1110 DEXTER AVE. N.

RECOMMENDATION MEETING
WEST DESIGN REVIEW BOARD
DPD #3024022
07/19/2017

MASSING OPTION 2 RECTILINEAR PARAPET

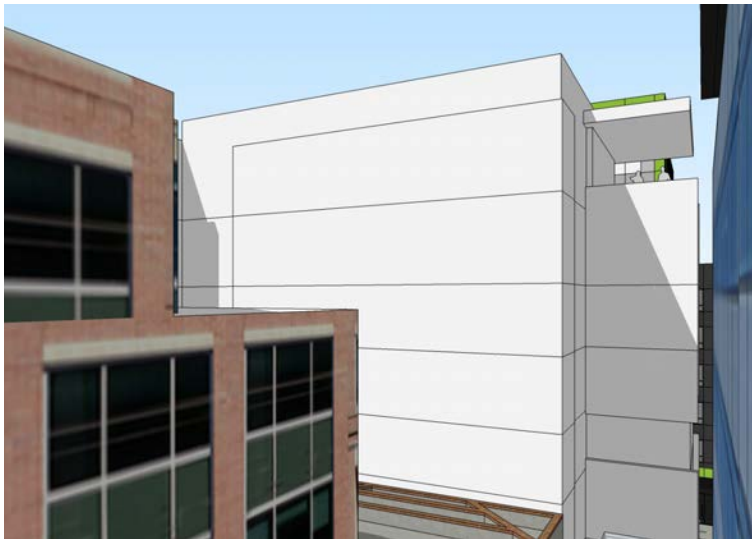
The design review Board encouraged the team to move forward with massing option 2, with its narrow, slot building expression within the neighboring context of larger box forms. The vocabulary of fin elements and extensive wood cladding were also supported to accent the slotted nature of the site and to differentiate the project from its surroundings. Flat rooflines with varied parapet heights and strong canopies were preferred by the Board as well.

The Board agreed the primary lobby entrance off Dexter should be located at or around the northwest corner as shown in massing option 3, engaging the generous patio and views to the lake found there. The Board agreed this was a special feature of the corner site on a view corridor, and the corner patio should engage the Dexter sidewalk and provide a welcoming entry sequence. Any required exit door on Dexter should be downplayed so an un-interrupted retail or amenity room can activate the majority of the Dexter frontage.

The entry at Highland Drive should have a good presence and the surrounding parking garage screening should contrast from the floating floors above and screen the garage from the pedestrians on the ground level.

DEXTER ENTRY SIGNAGE

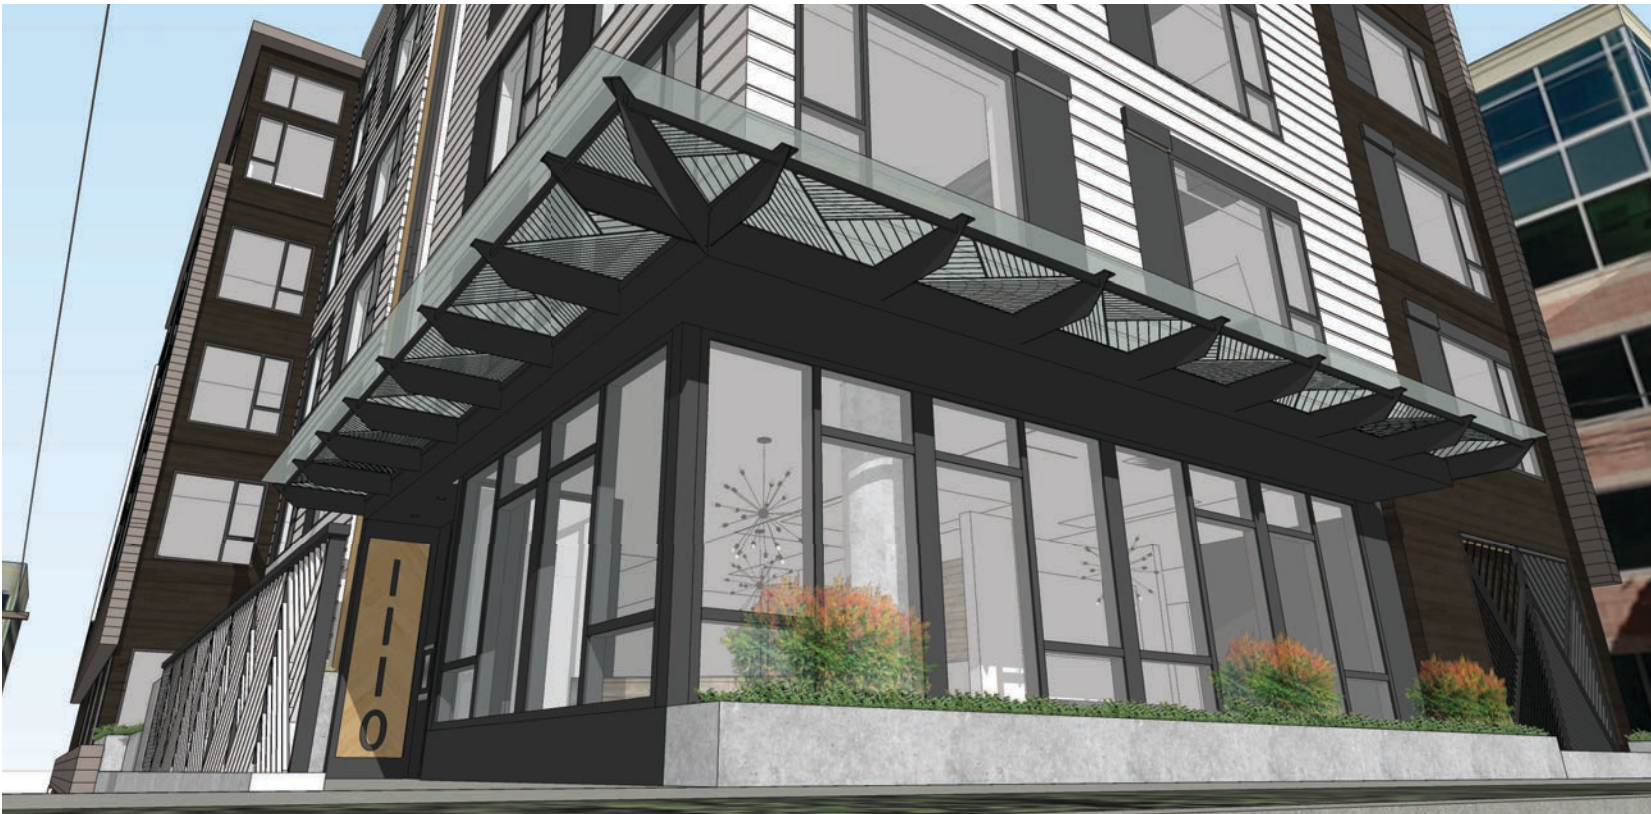
2D. The Board strongly supported the proposed use of wood cladding, as a welcome contrast from the predominant cement fiber panels in the context, but recommended more extensive use of wood texture and material [46,47]. The Board recommended the applicants develop a strong narrative to guide the disposition of exterior materials, including relationships or contrasts with context, and provide that narrative or story at subsequent meetings with staff and the DRB. (DC2; DC4-A-I)

Response: Wood cladding has been utilized in areas 'framed' by the fin elements. The wood will be stained dark, acting to contrast with the lighter colored materials utilized elsewhere. A lighter colored wood will be employed within constrained areas around the facade as accents. Downspouts are used as design elements within the accents to draw attention to the storm water retention planters.

DEXTER ENTRY CANOPY

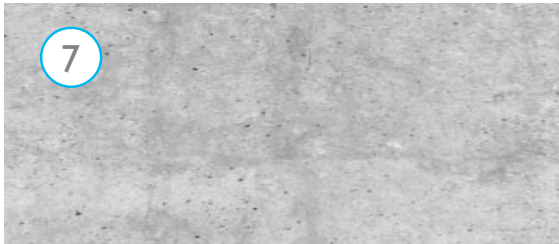
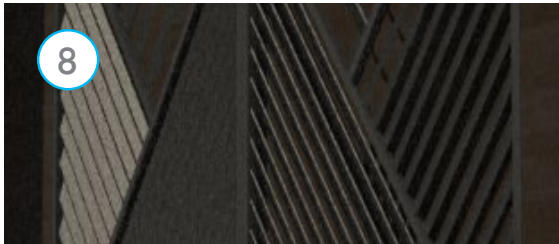
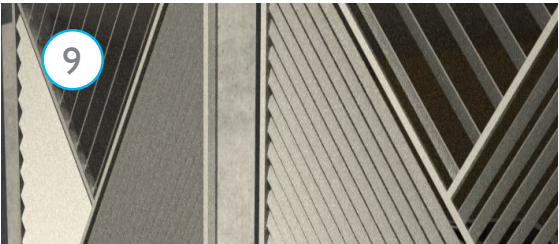
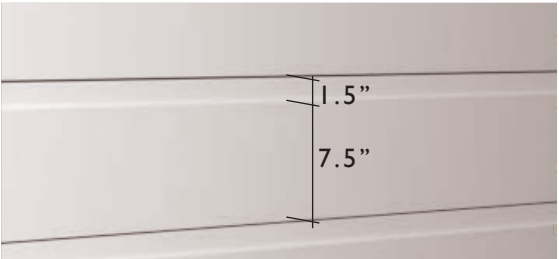
2C. The Board supported a strong canopy element, wrapping the northwest corner (to support the entry described under 3a below), similar to the one shown on pg 36, but possibly taller. (DC2)

Response: A corner canopy has been incorporated according to Board guidance, that wraps the northwest corner and supports the updated lobby location. The building facade below the canopy is largely glass, which wraps the building lobby. The pedestrian scale signage further reinforces the entry procession.

DEPARTURE REQUEST #1

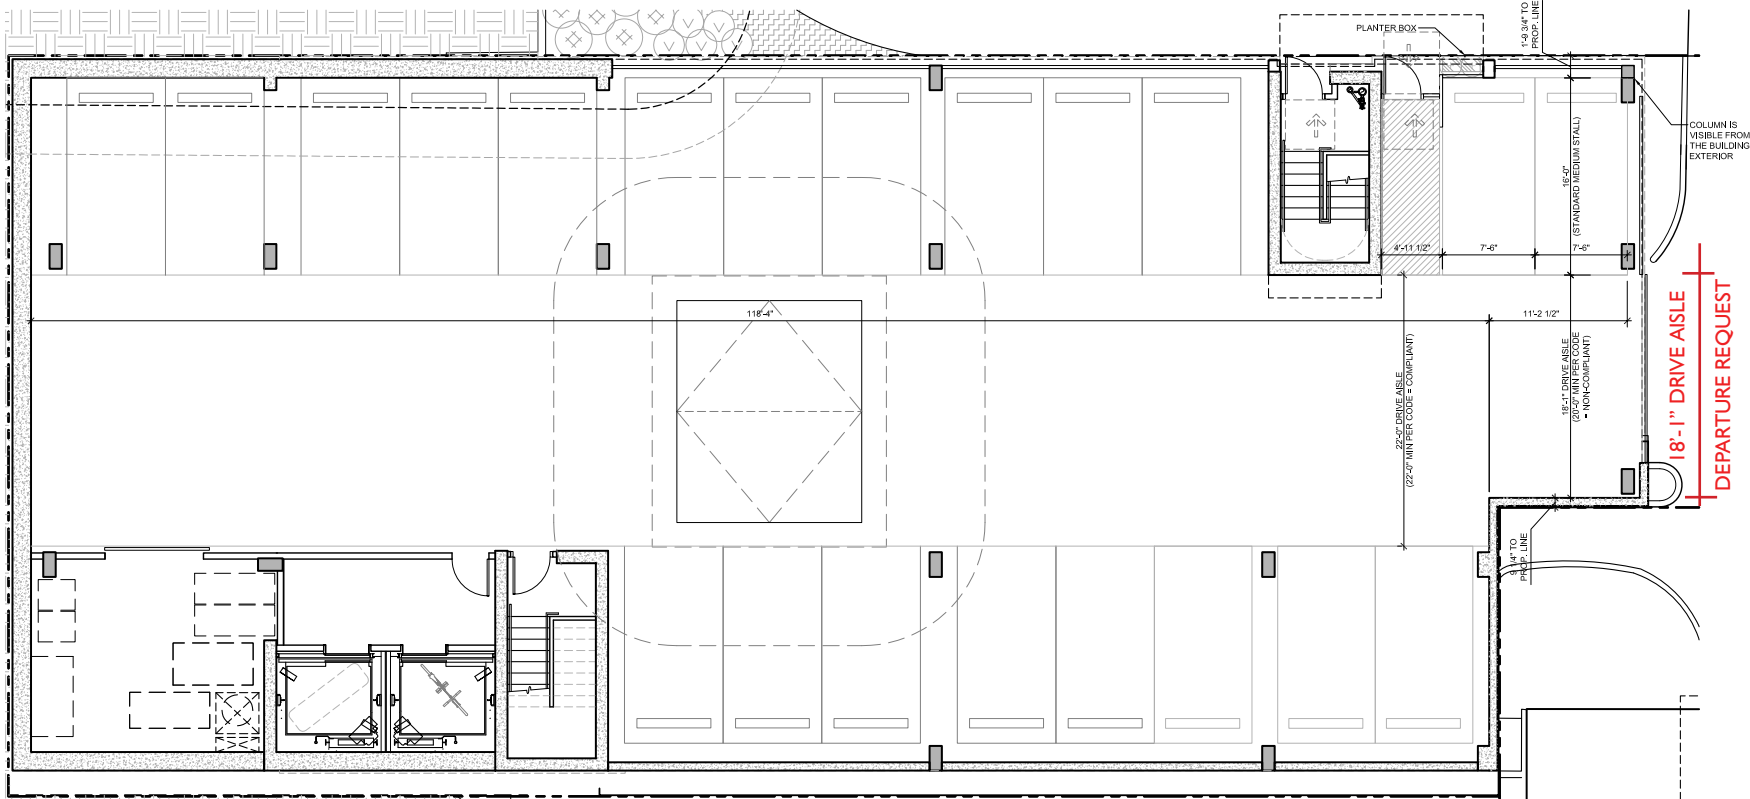
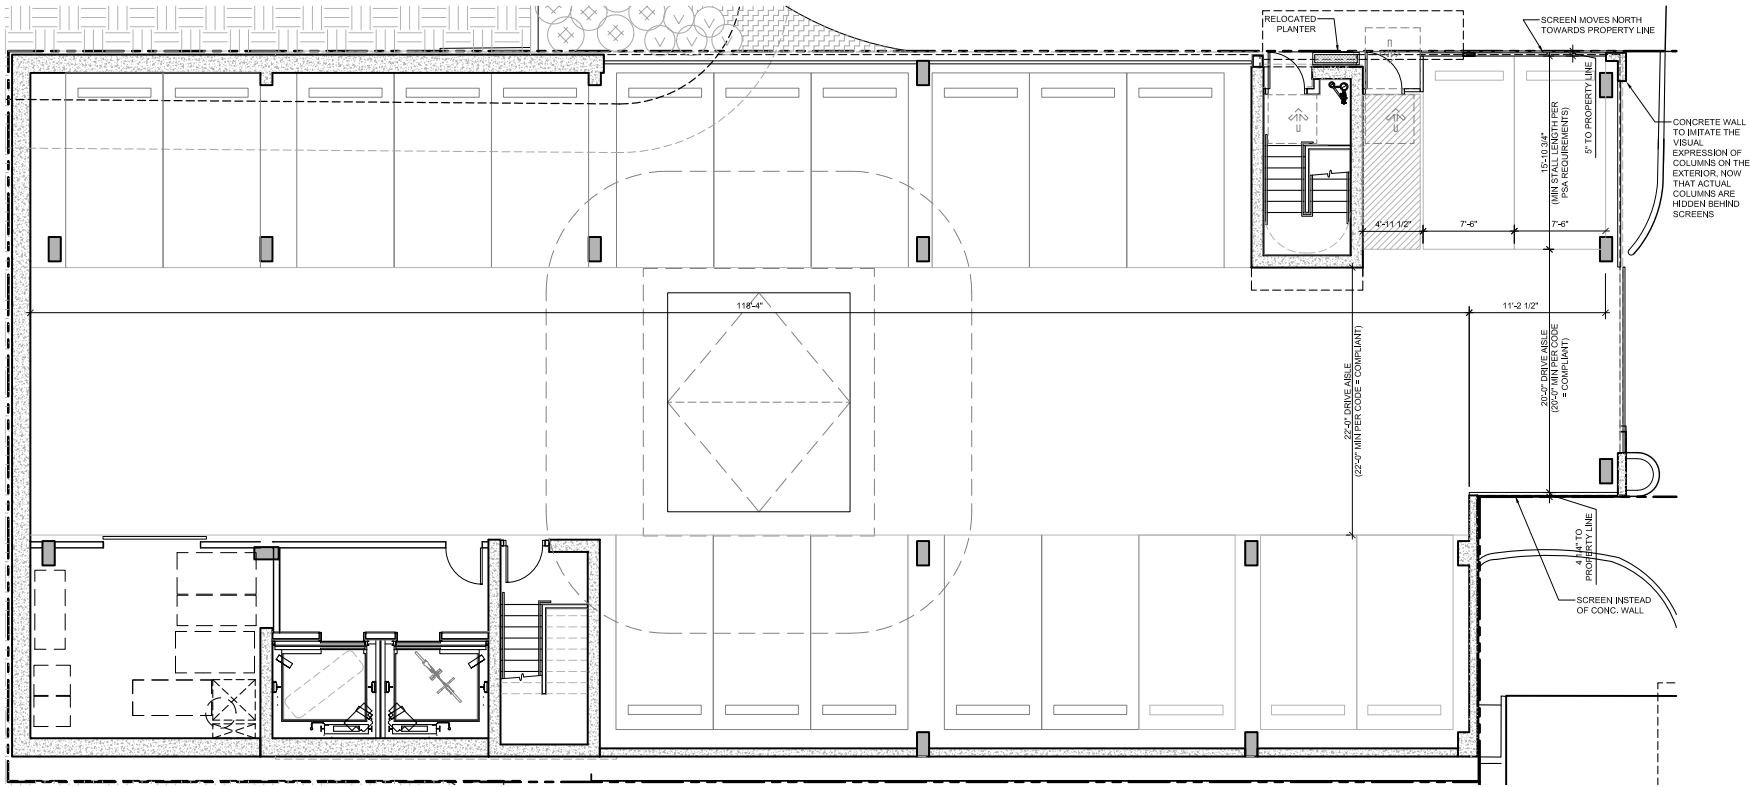
Minimum required drive aisle width for two way traffic is 20 feet for a 7.5 foot stall width at a 90 degree parking angle, and a 22 feet width for an 8 foot wide stall at a 90 degree parking angle.

The project proposes to meet the minimum drive aisle width requirements for 91% of the drive aisle length (118'-4"). The project requests a departure from the required drive aisle width for 9% of the length of the drive aisle (11'-2 1/2"), at a location where the garage necks down for vehicular entry at a narrow point in the property, and adjacent to the secondary pedestrian access point on Highland Drive.

The proposed departure condition better responds to the board guidance for a more generous and welcoming pedestrian access at Highland Drive, providing more relief from the property line and a more integrated planter box at the pedestrian gate.

The proposed departure condition creates a more identifiable and distinctive entry condition (PL3.A.1) and provides a more resolved ensemble of elements (PL3.A.4).
